APPLICATION NO.	FILING DATE	FIRST NAMED INVENTOR	ATTORNEY DOCKET NO.	CONFIRMATION NO.
10/568,617	02/16/2006	Wolfgang Peter	60291.000045	9357
21967 7590 06/21/2011 HUNTON & WILLIAMS LLP INTELLECTUAL PROPERTY DEPARTMENT			EXAMINER	
			KIRSCH, ANDREW THOMAS	
SUITE 1200	1900 K STREET, N.W. SUITE 1200		ART UNIT	PAPER NUMBER
WASHINGTON, DC 20006-1109			3781	
			MAIL DATE	DELIVERY MODE
			06/21/2011	PAPER

### **DETAILED ACTION**

Fig. 12 of U.S. PG Pub No. 2002/0050493 (Ball et al. hereinafter)

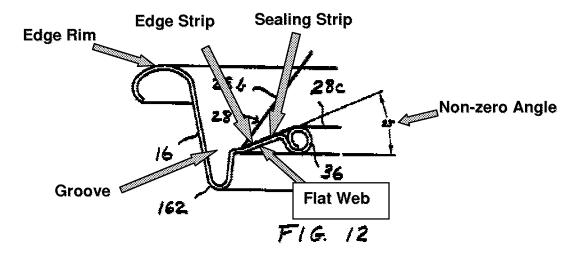
In re claim 2, with reference to Figs. 2A, 4A, 12 and 13 below, Ball et al. 6. discloses: A lever ring (16) for seaming to a body and for receiving a closure layer (28) affixed with an edge portion thereof by sealing (46) and for bridging an inner space of the lever ring, to close the body in a seam-connected position (page 9, paragraph [0095]), wherein (i) the lever ring has a surrounding continuous flat web (30) which radially outwardly merges into an edge rim (see Fig. 12) of the lever ring, a continuous surrounding groove (see Fig. 12) extending between the edge rim and the flat web; (ii) the flat web extends upwardly inclined (see Fig. 12) from a horizontal plane at an angle differing from zero (page 7, paragraph 76) and is provided with an inner curling (36) on its radially inner end so that a closure layer sealed to the flat web and subjected to a pressure force acting vertically to a plane of extension of the closure layer (as in peeling) introduces a substantial force component into a sealing zone, so that the force component extends in an extension direction of the sealing zone; and the inner curling (36) is configured to deflect the closure layer so that an edge strip is formed (see Fig. 12) that extends at an angle differing from zero with respect to a plane of the closure layer in the inner space of the lever ring (note that the angle of the closure layer in the inner space is effectively zero degrees, and that the area denoted "sealing strip" extends in a direction at an angle differing from zero).

- 7. In re claim 3, with reference to Fig. 12 above, Ball et al. discloses the claimed invention including wherein the angle differing from zero is between substantially 10° and substantially 90° (see Fig. 12: "23°").

- 8. In re claim 5, with reference to Fig. 12 above, Ball et al. discloses the claimed invention including wherein the angle is between substantially 25° and 35° (page 7, paragraph 76).

- 9. In re claim 8, with reference to Figs. 2A, 4 and 13 above, Ball et al. discloses the claimed invention including wherein said receiving and sealing of the closure layer (28) is a sealing of an edge portion of the closure layer in a sealing zone (46) the flat web (30) which sealing zone extends circumferentially (paragraph 0074, see Fig. 15).

- 10. In re claim 12, with reference to Fig. 13 above, Ball et al. discloses the claimed invention including wherein the sealing zone as a strip extending circumferentially (46) has a substantial width of extension on the flat web (30), the width being more than half a width of the flat web (see Fig. 13 above).

- 11. In re claim 14, with reference to Fig. 12 above, Ball et al. discloses the claimed invention including wherein the groove (see Fig. 12) is wedge-shaped with a rounded bottom and is formed between a chuck wall extending towards the surrounding lid rim (2) and the surrounding inclined flat web (30).

- 13. In re claim 28, with reference to Fig. 12 above, Ball et al. discloses the claimed invention including wherein the flat web (30) comprises radially inwards an inner curling (36).
- 14. In re claim 29, with reference to Fig. 12 above, Ball et al. discloses the claimed invention including wherein the angle differing from zero is between substantially 10° and substantially 90° (see Fig. 12: "23°").

15. In re claim 31, with reference to Fig. 12 above, Ball et al. discloses the claimed invention including wherein the angle is between substantially 25° and 35° (page 7,

16. In re claim 34, with reference to Figs. 2A, 4 and 13 above, Ball et al. discloses the claimed invention including wherein said receiving and sealing of the closure layer (28) is a sealing of an edge portion of the closure layer in a sealing zone (46) the flat web (30) which sealing zone extends circumferentially (paragraph 0074, see Fig. 15).

17. In re claim 37, with reference to Fig. 12 above, Ball et al. discloses the claimed invention including wherein the groove (see Fig. 12) is wedge-shaped with a rounded bottom and is formed between a chuck wall extending towards the surrounding lid rim (2) and the surrounding inclined flat web (30).

Fig. 2 of U.S. Patent No. 6,082,944 (Bachmann et al. hereinafter)

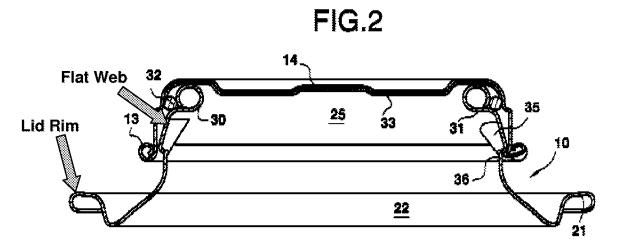
- 31. Claims 13 and 36 are rejected under 35 U.S.C. 103(a) as being unpatentable over Ball et al. as applied to claims 1 and 2 above, and further in view of U.S. Patent No. 6,082,944 (Bachmann et al. hereinafter).
- 32. In re claims 13 and 36, with reference to the Figures above, Ball et al. discloses the claimed invention including an alignment of the flat web that projects steeply upwards.
- 33. Ball et al. fails to disclose wherein the inner curling (at the flat web) axially projects above an upper side/level of the lid rim.
- 34. However, with reference to Fig. 2 below, Bachmann et al. discloses a can end configuration with a removable closure layer (14), in which an inner curling (30) axially projects above an upper side/level of the lid rim (see Fig. 2).

35. Therefore, it would have been obvious to one of ordinary skill in the art at the time of the invention to have modified the curl of Ball et al. to be elevated in relation to the upper side/level of the lid rim as taught by Bachmann et al. Such a modification would have allowed for improved mouth construction for better pouring and drinking comfort (column 2, lines 15-23).
